Floyd Hill - Project Leadership Team and Technical Team

Meeting Summary

July 16, 2020, 1:00 PM to 3:00 PM

Screenshot of modeling tool illustrating rock cuts.

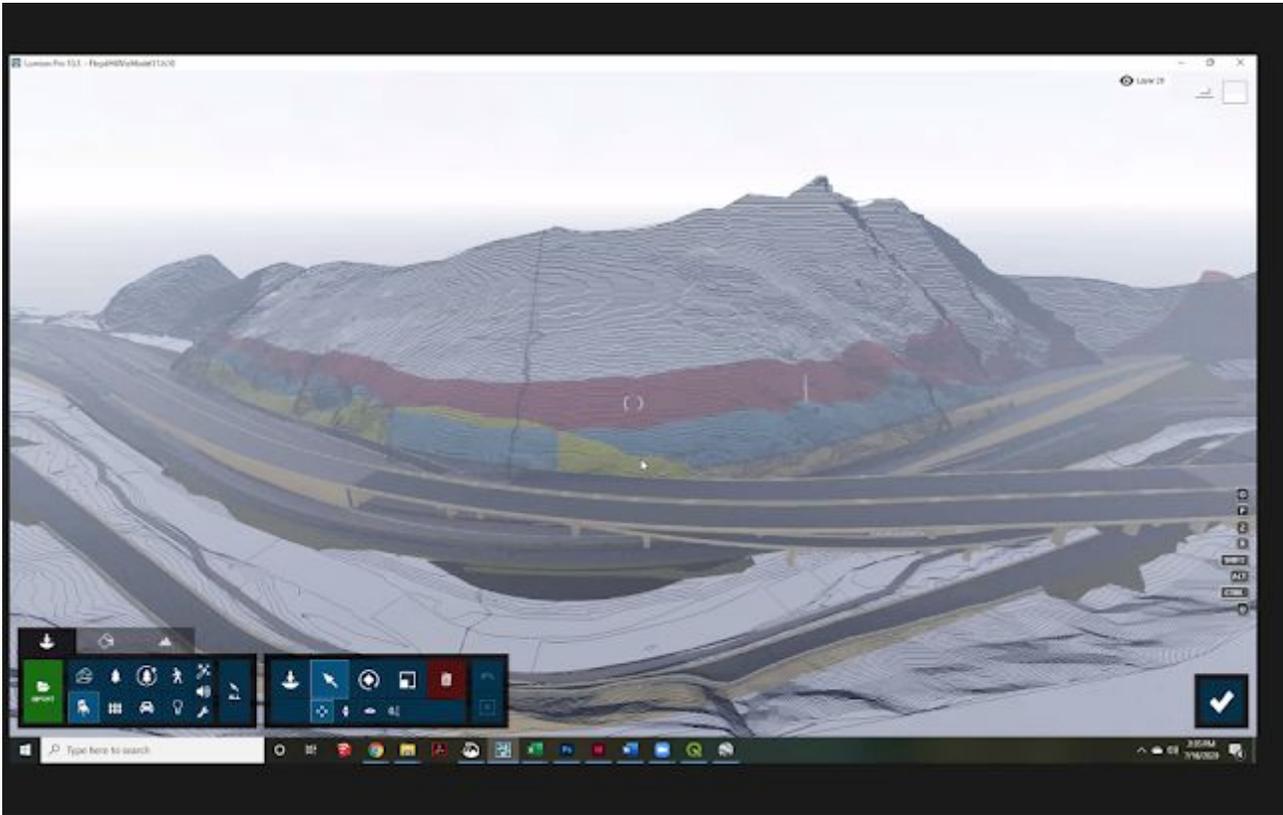
The PLT/TT had lengthy discussion about the rock cuts throughout the project area in each of the modeled alternatives. Rock cuts vary in height and length, with the highest and longest rock cuts for the Tunnel Alternative, North Frontage Road option.

Comment: Currently, the model looks like it is taking out a large area of Clear Creek. If that's not the case, then we'll want to see that better illustrated.

Comment: We continue to have concerns about the Tunnel South option's impact to the Greenway. That will be a consideration for this PLT in moving forward. Clear Creek County Open Space acquired that land to have a connected piece along the Greenway.

Screenshot of modeling tool from birds-eye view of one portion of the project corridor.

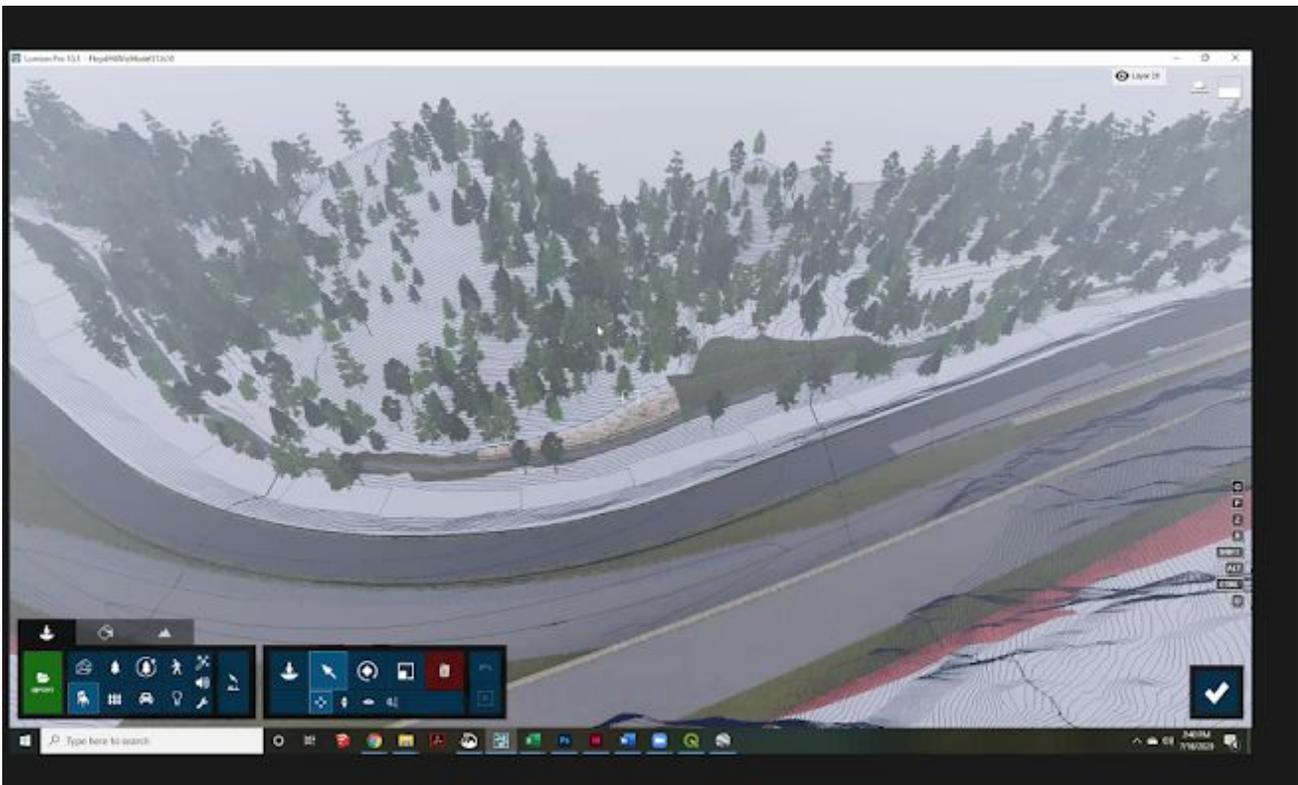
Comment: The original concept was “save the south side.” Does the Canyon Viaduct Alternative preserve the south as well as the Tunnel Alternative does? I don’t want to drift away from our original intent to preserve the south side.

Comment: The fact that the viaduct is so high does not seem to be the big impact to the south side that the PLT/TT was concerned with constructing the Frontage Road / US 6 on the south side of the creek.
